POWER PLANT - RELAY BOX - MOUNTING BRACKET WITH INCREASED HEIGHT SUPPORTS AND ALTERED CLIPPING LUGS - CATEGORY CODE A5 MODEL:6 - CATEGORY CODE A1 MODEL:7 - MOD.ENG-71-0113

V2500-ENG-71-0113

Location of relay box support bracket
Fig.1

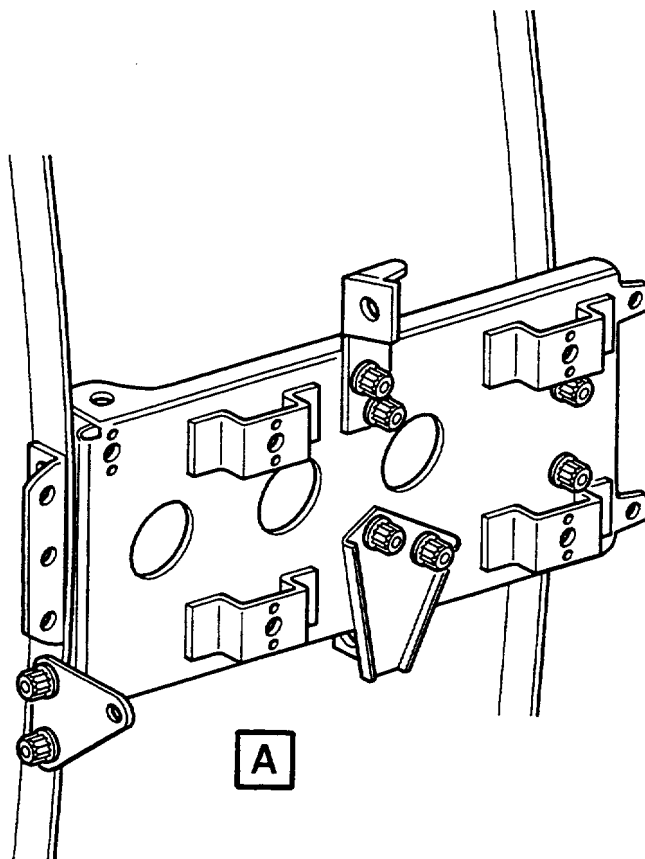
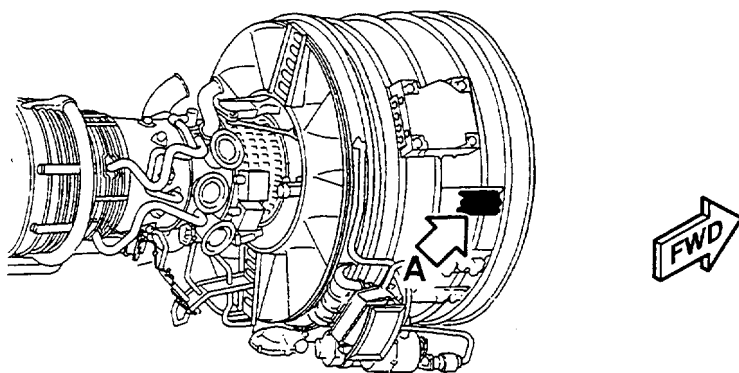
Install the new 6A5626 relay box mounting bracket to the fan case by the approved procedures in the Engine Manual, 72-00-32, Installation (Refer to Figure 1 and 1.K. (2)).

Relay box support bracket - before and after alteration
Fig.2

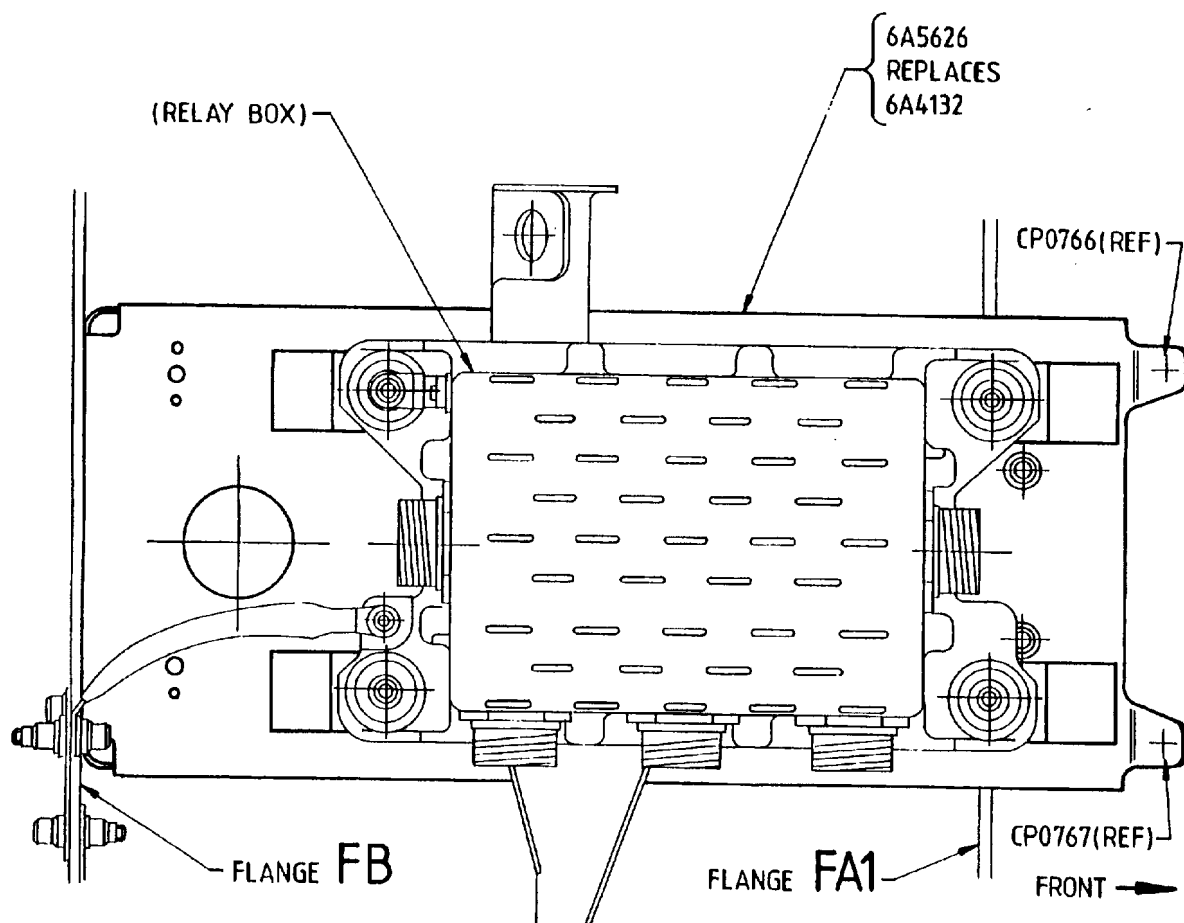
The four bracket supports are increased in height by 0.314 in. (8 mm). The clipping lugs (for CP 0766 and CP 0767) are set at an angle of 25 degrees minimum instead of 20 degrees minimum.
